INVITATION FOR BID (IFB) No. IFB-PAG-CIP-022-002
REBID OF THE CONSTRUCTION REHABILITATION OF HOTEL WHARF AND HIGHWAY 11
ROADWAY RECONSTRUCTION

ADDENDUM NO. 3
DATE: January 24, 2022

Invitation for Bid IFB-PAG-CIP 022-002 Rebid of the Construction Rehabilitation of Hotel Wharf and Highway 11 Roadway Reconstruction January 24, 2022

QUESTIONS, CONCERNS, AND RESPONSES

Q2. ASPHALTIC CONCRETE PAVEMENT Section 02510 Item 2.01 A. :

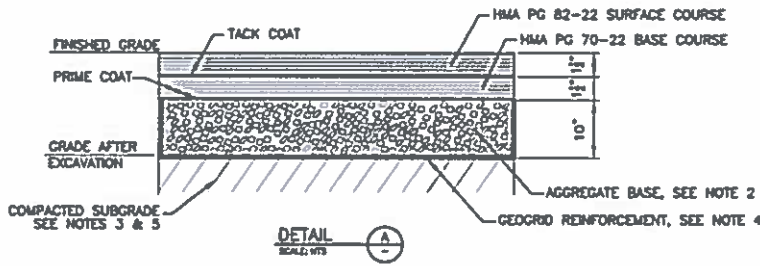
"Asphalt Cement shall be ASTM D946 penetration grade 60-70 or 85-100, in accordance with Specification No. OICC Marianas 123C."

On-island, Hot Mix Asphalt (HMA) Concrete Mix produce is using the AR16000 grade Asphalt cement for Federal Highway Projects. Please confirm AR16000 will be acceptable to the project.

R2. Response: The request to use AR16000 grade asphalt is acceptable for use on the project. The DPW pavement specifications FP-03 and SCR-402 should be followed, including the testing requirements.

Q5. For the Hotel Wharf, Asphalt Conc. Pavement Section in drawing is calling out:

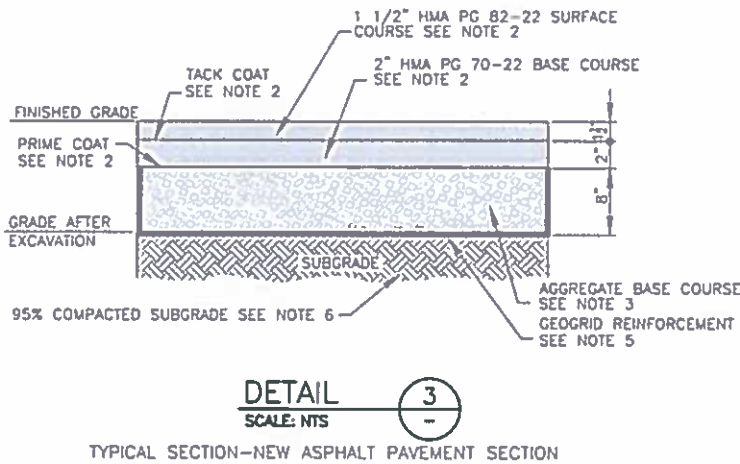
For the Hotel Wharf Asphalt pavement, shows 2" and 1.5" thick layers. We would like to confirm if it's acceptable to place 2" and 1.5" thick of same job mix (binder course with AR16000). Please confirm this is acceptable.

R5. Response: Request denied.
